# PREPARED FOR THE PLAN COMMISSION

Project Address: 1403 Gilson Street

**Application Type:** Demolition and Conditional Use

Legistar File ID # 31539

Conceptual Designs for Gilson Street Redevelopment

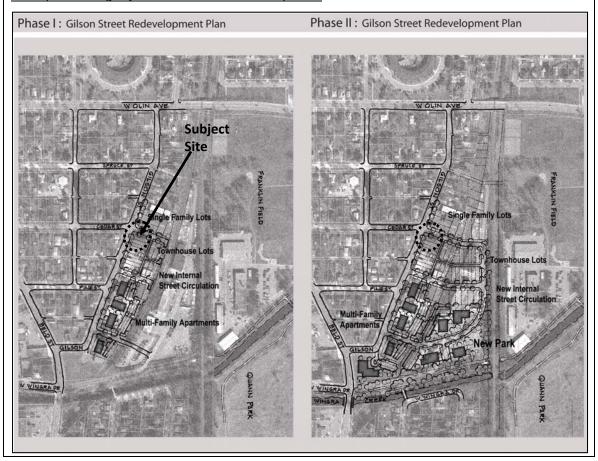
Staff discussed with the applicant the recommendations in the plan, but understands that at this time, relocation of the business to another site is not economically feasible. Further, staff pointed out that the location of the proposed new building will prohibit the eastward extension of Cedar Street (see images above) for the foreseeable future. The business could theoretically operate their office uses from a temporary trailer on the site, but needs the existing building for their shop uses while the proposed building is under construction. Thus, the proposed building must be constructed on the northern portion of the property, opposite Cedar Street in order to avoid a major disruption to the business. In consideration of this issue, staff notes that the street extension is only conceptual at this point, and would necessitate the removal of another building east of this site

as well. The extension may only occur with a significant redevelopment of the area into residential uses, which would likely involve the deconstruction and removal of the proposed building, along with others.
